Product hierarchy no. *			Part no.	SBU	Type / Description	Customer part no.
SBU	PG	PGU	Type			
02	007	043	0000002295	4795.0000	Connectors	4795 Appliance Outlet

**2 Type of change**

With the production of the new tool the Tension relief has changed too.

4795					0118.2126	
creation date	created by	release date	released by	notification no.	revision	page
2012-09-13	sha	2012-09-14	sha	23911		1 of 1

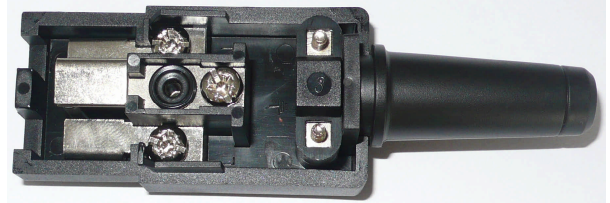
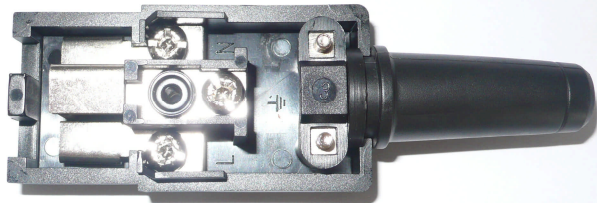
The flange of the Tension relief was round, what caused an insufficient hold of the Tension relief.

NEW the flange of the Tension relief is square, what improves the holding of the Tension relief.

According to 60320-1 sect. 22 (Cords and their connection) the Tension relief with the round flange could fall out. As there have been made new tools for the moulding parts the holding of the Tension relief got improved with a square flange.

Form: Square flange on the Tension relief  
 Fit: n/a  
 Function: Better holding of the Tension relief  
 Production Site: n/a  
 Product Label: n/a
